Rockbank North PSP

Submission for the GAA draft Precinct Structure Plans open for public comment

Figure 1: Annotated plan showing bicycle comments

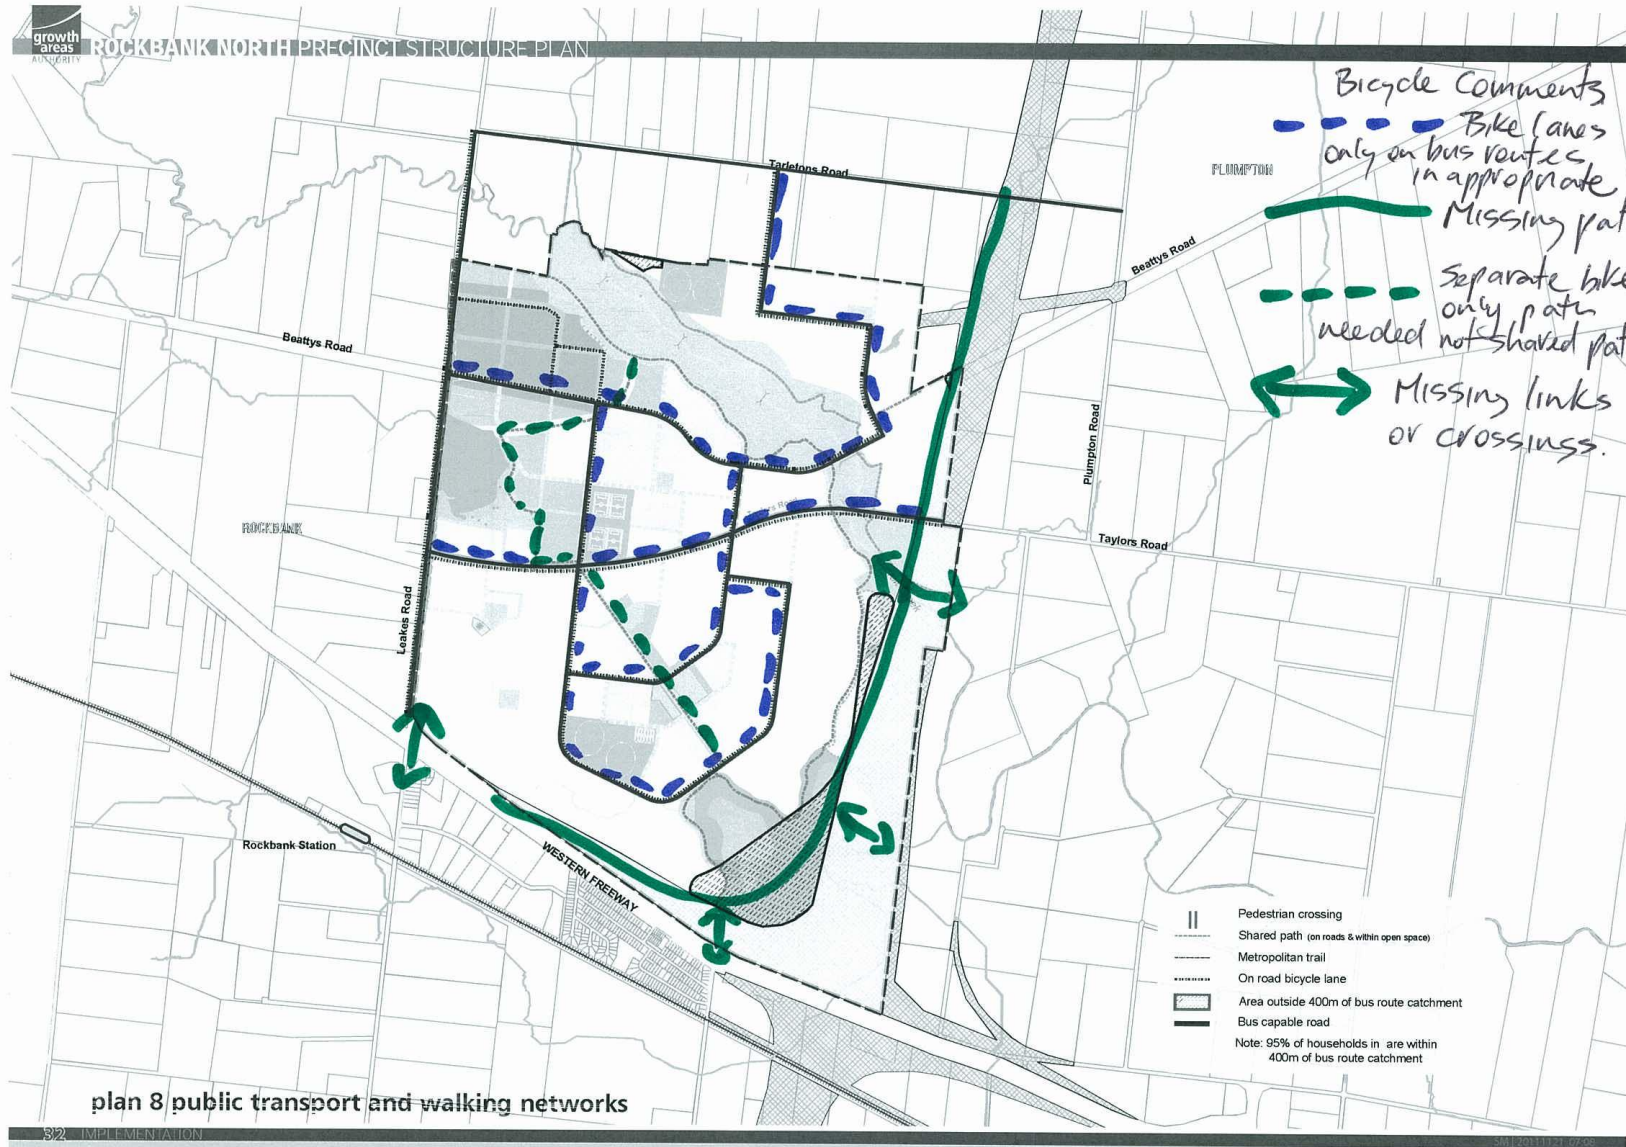
General note – the lack of a scale on the plans made reading and interpreting difficult especially when assessing distances.

Connections to destinations - The south eastern Local Town Centre (LTC) is well connected via off-road paths and on-road lanes. The smaller south western local convenience centre is not well connected with no marked bicycle routes (on-road lanes or off-road paths) linking it to the wider bicycle network. The future Major Town Centre is also well connected via paths and lanes.

Access into Town Centres – Access into and through the southern LTC is well connected by an off-road path and on road lanes. The northern Major Town Centre is also well accessed by on-road lanes but has no off-road path to internal destinations within the Centre.

Access to Schools, Parks Community Centres – None of the schools proposed has an off-road path connection to the wider off road path network. Off-road paths on connector streets would help overcome this. The same is true of the community centres. This is a critical deficiency of the plan.

Crossing of barriers - The Outer Metro Ring road to the east is a potential significant barrier for permeability to the east while the Western Freeway is a potential barrier to the south and to Rockbank Station. No paths or path crossings are shown for these corridors. At least four crossing are needed: one at Leakes Rd, one of the Western Fwy in the SE, one of the OMR in the SE to follow the drainage reserve path and one for the Kororoit Creek path at the OMR to connect to the eastern extension of this path. Both crossing of the Western Fwy could provide connections to Rockbank Station. Multiple crossings of Kororoit Creek are shown which allow access across this

Connector streets with schools, parks, community facilities – most schools, parks and community facilities will be located on connector streets. These streets are likely to carry significant motor vehicle traffic volumes at moderate speeds (50-80km/h). On-road bike lanes on these roads are unlikely to be used by school children, family groups or novice riders and separated off-road paths, with clear and unhindered crossing of minor streets, are more appropriate. They also serve to connect to the wider off road path network alongside parks and green corridors. Beattys Roads is a candidate, as is the middle north south connector which passes schools, community facilities and higher density areas.

Connector streets with buses and bikes - Most of the connector streets have marked on-road bike lanes on potential bus routes. This may lead to conflict between buses and bikes as buses must cross and recross the bike lane to load and unload passengers. Off-road bike paths are more appropriate on these routes as bicycles can run behind stops and high frequency bus services will not be hindered in their operation. Off-road bike paths also mean a narrower paved road width which is easier for pedestrians and potential bus passengers to cross.

Bike lanes on high speed roads – Taylors and Leakes Rd are higher speed arterial roads which propose on-road bike lanes alongside motor vehicles travelling above 70-80km/h. Austroads Guides to Road Design (2009, 2011) recommend separated bike paths for these traffic regimes and these are much more likely to be used by less confident and novice bike riders such as children and family groups who do the majority of riding in the community via short trips to school, shops and friend and for recreation. Separated, bike only paths are more appropriate for these roads but care needs to be taken to design intersections and cross overs (driveways etc.) to provide clear and unhindered passage for bike riders. A bike path that stops and gives way at minor intersections does not properly provide or encourage bike riding.

Separated bike paths from pedestrians – where high volumes of bikes riders and pedestrians are expected, especially at peak times such as before and after school, there is the potential for conflict on shared paths. This can be seen on some of the most popular existing shared paths in Melbourne such as the Main Yarra Trail and the Inner Circle Trail where high volumes of bike riders and walkers mean both are disadvantaged. This can discourage walking and cycling; especially by the more vulnerable who may be fearful of venturing onto a busy shared space. Widening of the path only works up to a certain point and then it makes more sense to provide separated bike and pedestrian paths. Experience and modelling has shown that where peak bicycle volumes exceed 200 bikes per hour with more than 100 pedestrians per hour then separate bike and pedestrian paths are appropriate. The diagonal shared path proposed connects to several high demand areas and past some high density residential areas so is likely to see high numbers of bikes and pedestrians. A separated bike path is appropriate for this path rather than a shared path.
